Product Upgrade Bulletin 130702FRV

**PRODUCT(S)
AFFECTED:**
American
Heritage,
American Eagle,
American
Tradition,
manufactured
through June 20,
2013

SUBJECTS:
Installing
resistors on the
multiplex system
to correct
dimmer module
freeze-up

ISSUE DATE:
July 2013

Figure 1

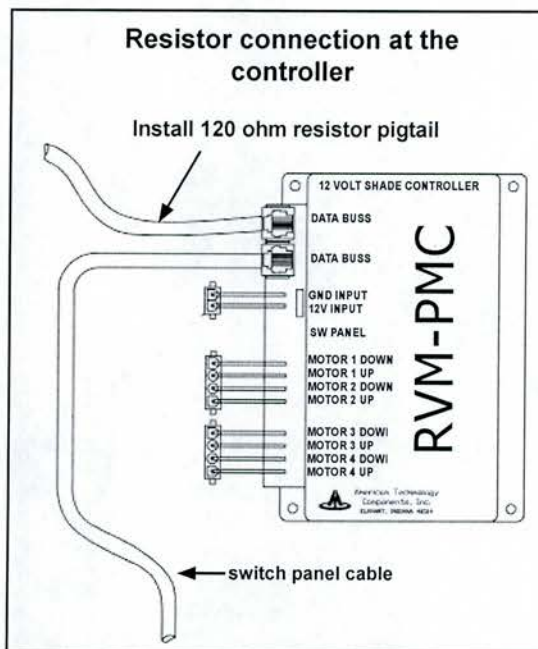
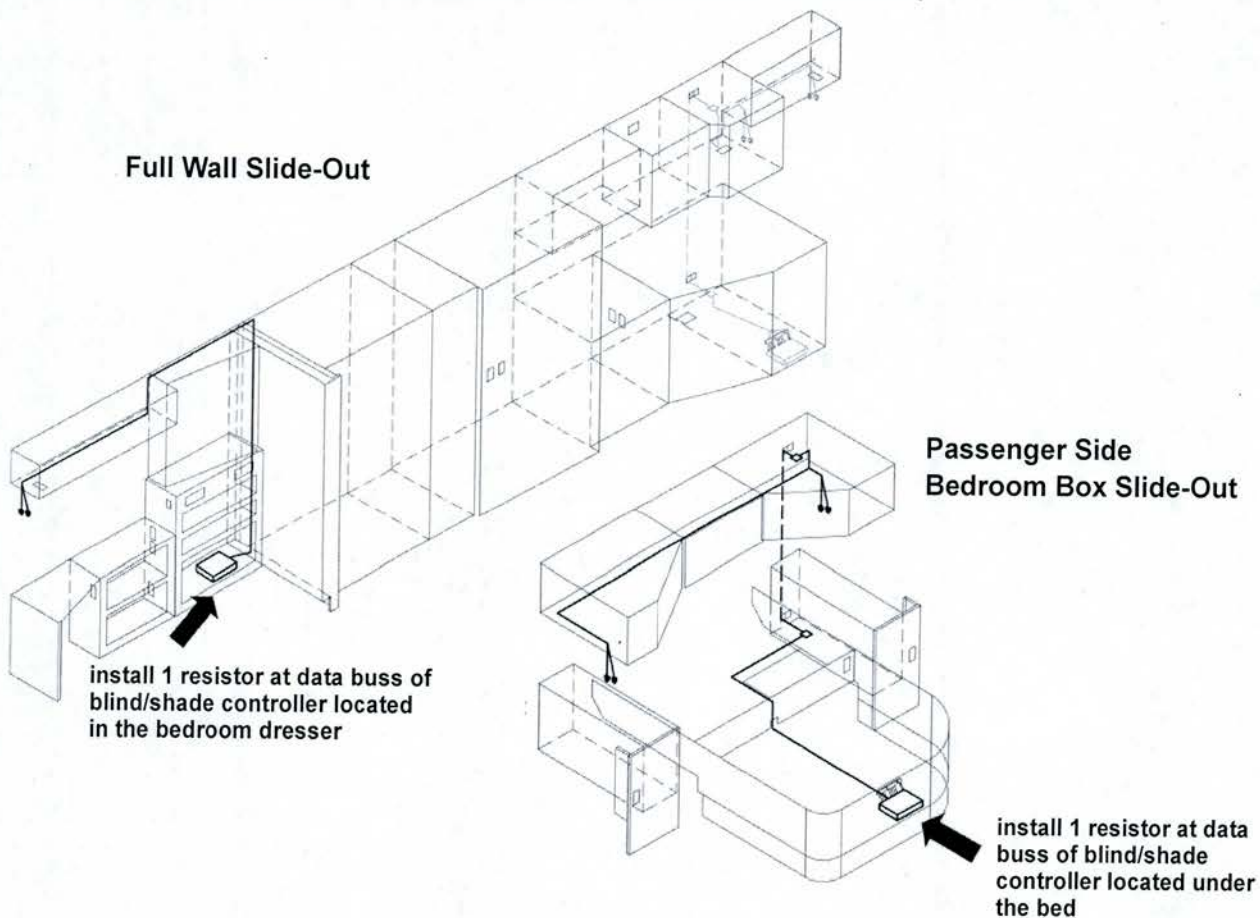
Note: For units equipped with Option #594 Power Shade Package, the resistors should be plugged into the data buss on the blind/shade controllers (Figure 1); for units not equipped with the option, plug the resistors into the switch panels (Figure 2).

Resistor installation locations for units equipped with optional power shade package
(Note - typical installation shown - actual floor plan varies according to model)

Figure 2

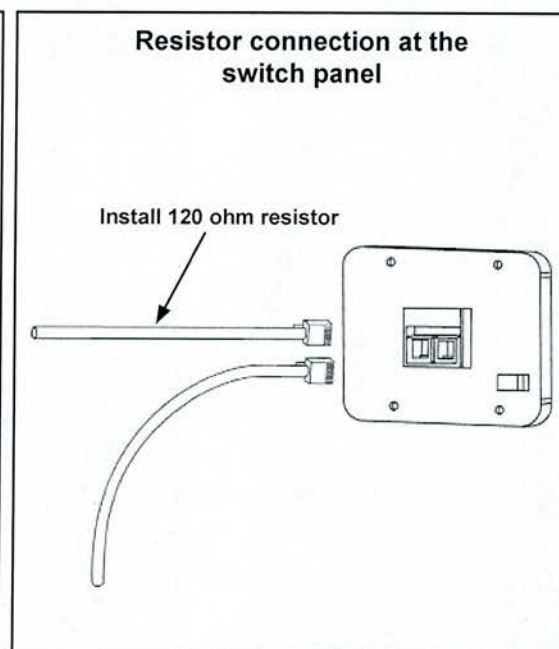
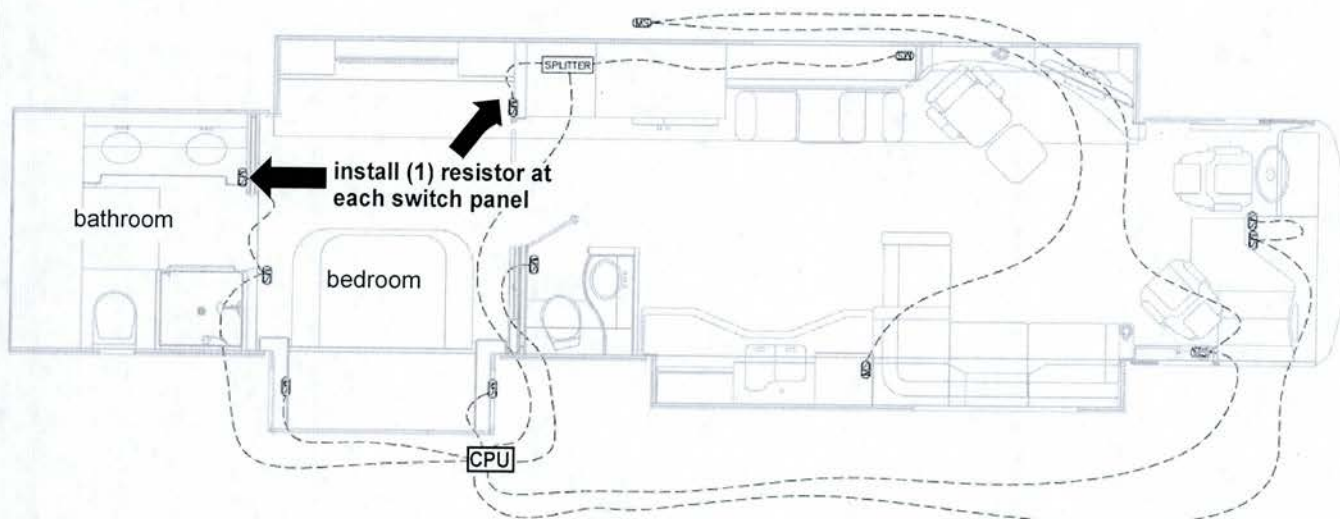
Resistor installation locations for units not equipped with optional power shade package
Note - typical installation shown - actual floor plan varies according to model)
